SCOPING REPORT: Scoping and Environmental Impact Assessment (EIA) Process for the Proposed Development of a Solar Photovoltaic (PV) Facility (Kudu Solar Facility 7) and associated infrastructure, near De Aar, Northern Cape Province

APPENDIX E.10: COMMENTS RECEIVED FROM STAKEHOLDERS DURING THE 30-DAY REVIEW OF THE DSR 72

Figure 1: Horizontal Axis Wind Turbine ^[2]

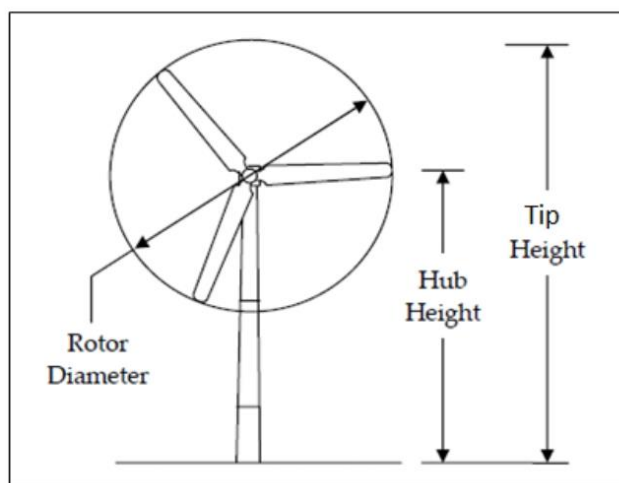
- Applicants should not position any wind turbine in the line of site between and two Eskom Radio Telecommunication masts. It should be proven that Eskom radio telecommunication systems (mainly microwave systems) will not be affected in any way by wind turbines due to the criticality of this infrastructure in terms of network operation. Eskom Telecommunications should be engaged on this matter.

- If the position or size of any turbine changes and subsequently infringes on any of the above stated setbacks, a request for relaxation must be sent through to Eskom as per the point mentioned above.
